CITY OF ALBUQUERQUE

RE: 142 40th St. SW
Grading and Drainage Plan
Engineer's Stamp Date: 09/05/23
Hydrology File: K12D037

Based upon the information provided in your submittal received 09/05/2023, the Grading & Drainage Plans **are not** approved for Building Permit and Grading Permit. The following comments need to be addressed for approval of the above referenced project:

ENGINEER'S SEAL	LOT 6, Blk 2 New Bridge Acres Add 142 40TH STREET	DRAWN BY DEM
		DATE 11-5-22
9/5/23	GRADING AND DRAINAGE PLAN	LOT 6, Blk 2 New Bridge Acres Add, DVS SHEET # C1
DAVID SOULE P.E. #14522	 <i>Rio Grande Engineering</i> PO BOX 93924 ALBUQUERQUE, NM 87199 (505) 321-9089	JOB # _____

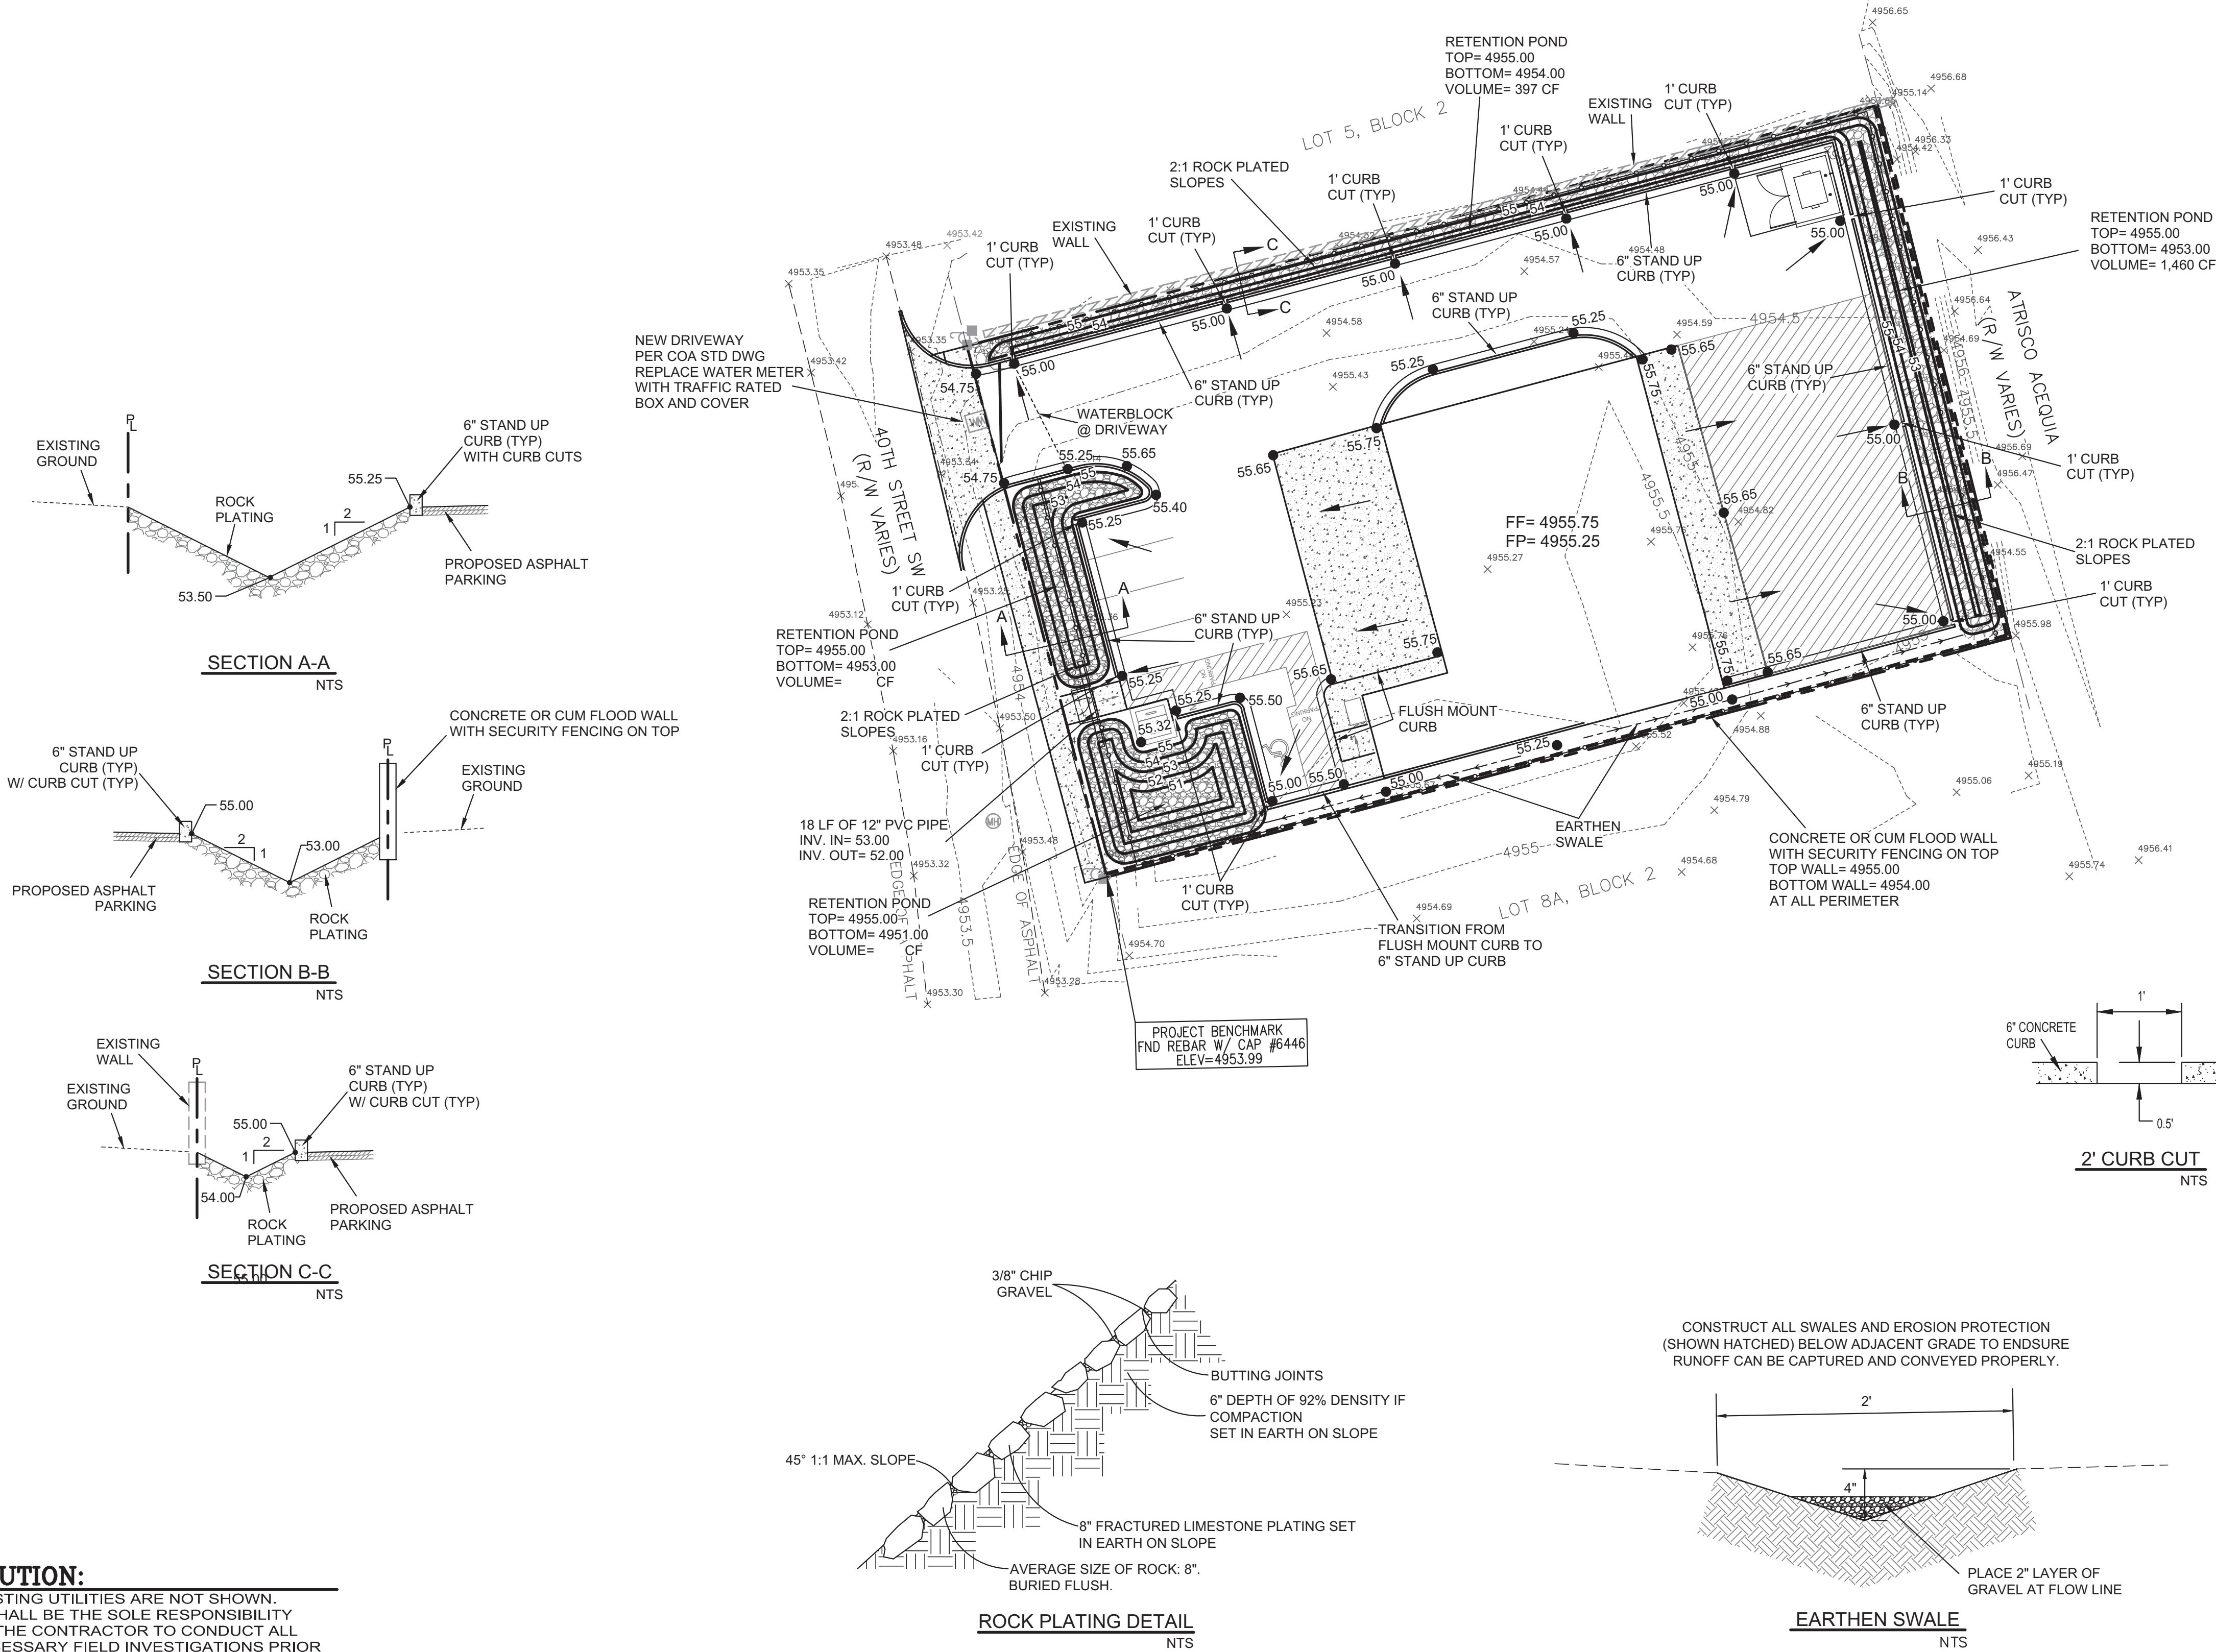
1. Please provide the stormwater quality calculation, multiply the impervious area by 0.26 inches for redevelopment sites.
2. please follow Article 6-5 Valley Drainage Criteria of the DPM. The following conditions must be applied to the site:

- a. The maximum percent impervious of the lot and the contributing area may not be greater than 45%.
 - b. Pad elevation shall be a minimum of one (1) foot above the 100 year 10-day stormwater surface elevation.

- c. The flow between the front yard and back yard cannot be obstructed. The stormwater must be allowed to equalize to the same level between the front yard and back yard.

- d. A permanent perimeter wall or barrier around the development is required to contain the 100 year 24 hour storm developed runoff.
 - e. The high point of the street should be four inches above the 100 year 10-day stormwater surface elevation.

- f. The retention pond is the 100 year 10-day volume and not the 100 year 24 hour volume.
